Subject: Meeting notes

**WATERVIEW  
LIFT STATION  
RELOCATION**

ISSUANCE INDEX	
DATE	11/16/2022
PROJECT PHASE	60% PLANS

**SITE PLAN  
PROPOSED  
OVERALL**

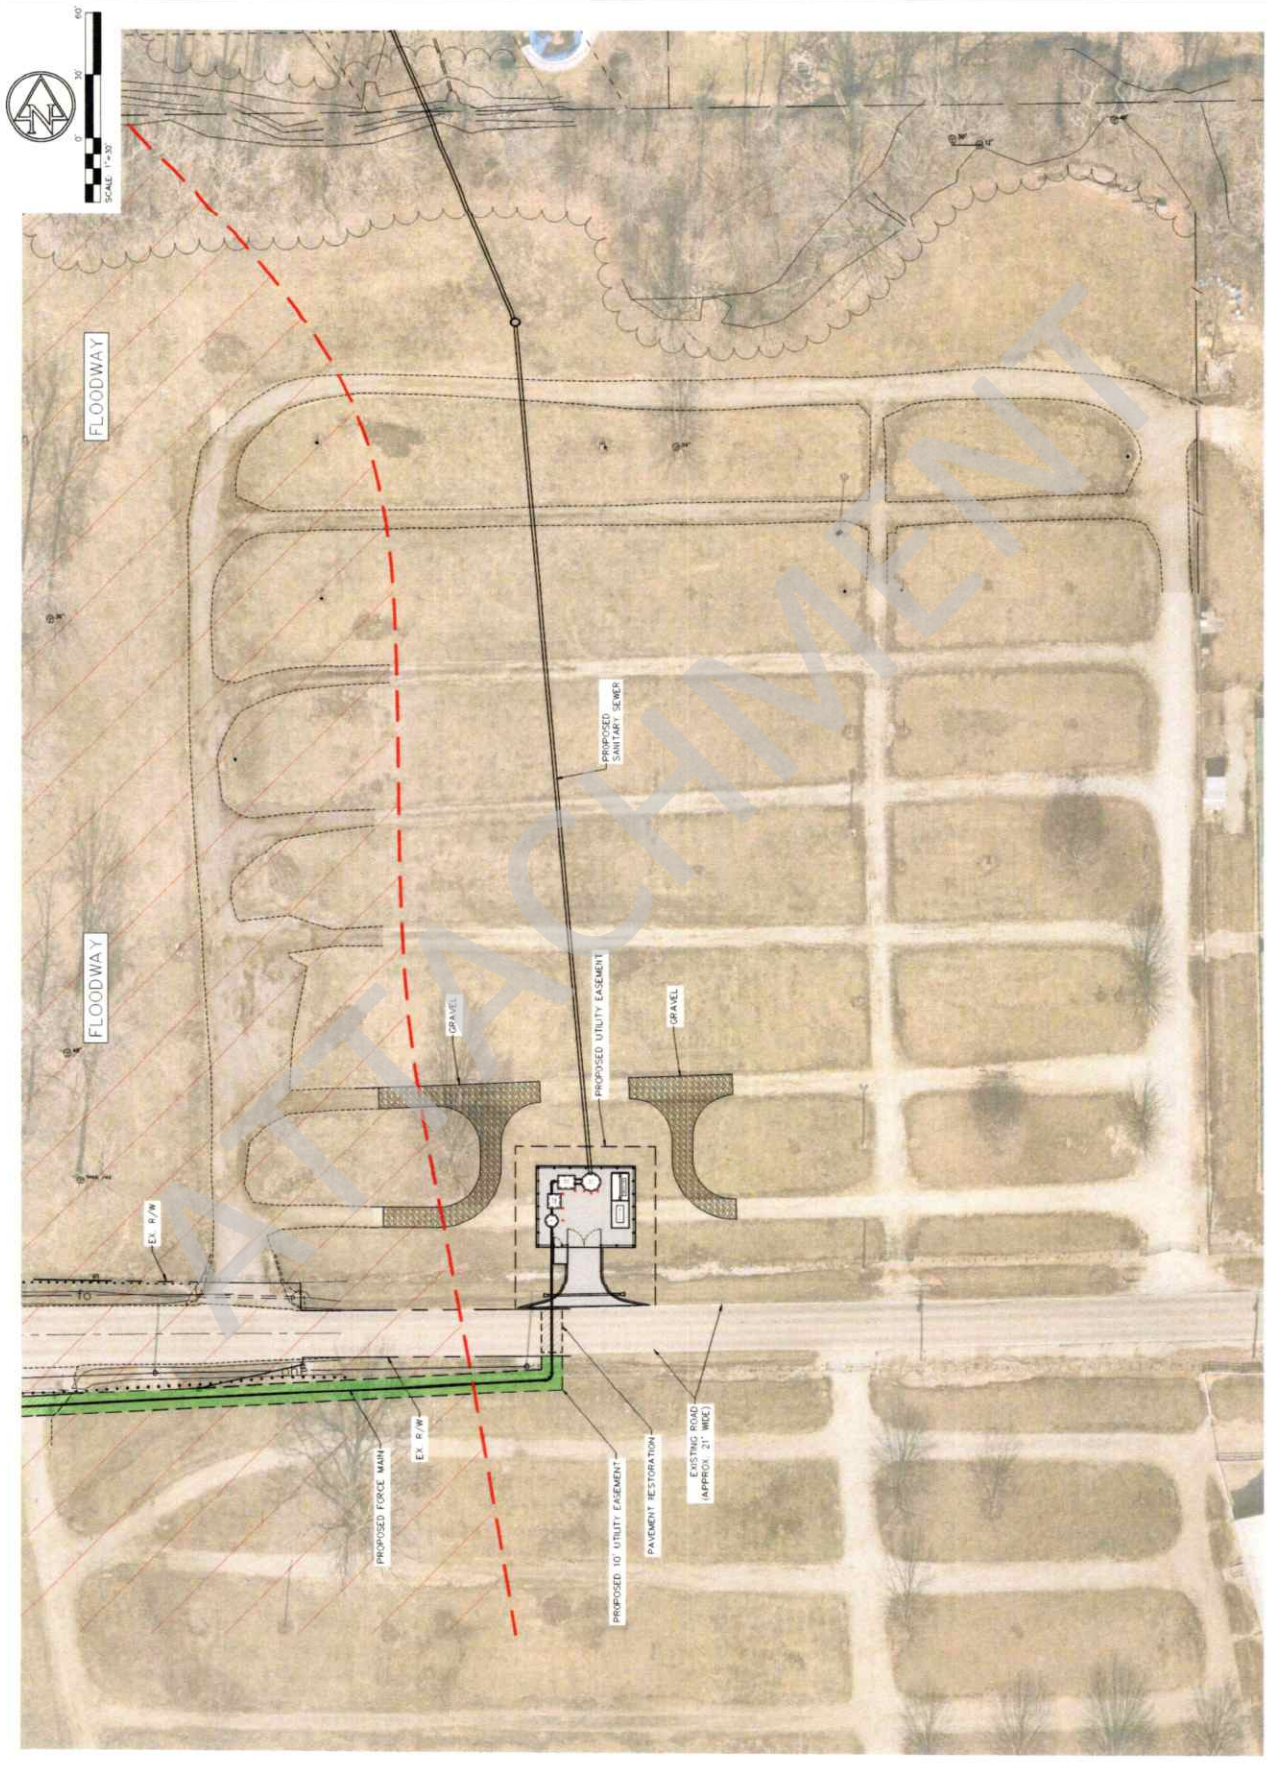
The concrete pad for the lift station will be 47 x 40. There will be additional ground needed for fencing and landscaping.

The line extending from the lift station south to connect to a force main will be an open street cut.

The force main south of Park Avenue will be directionally bored.

The north manhole needs to be changed to move it out of the parking area.
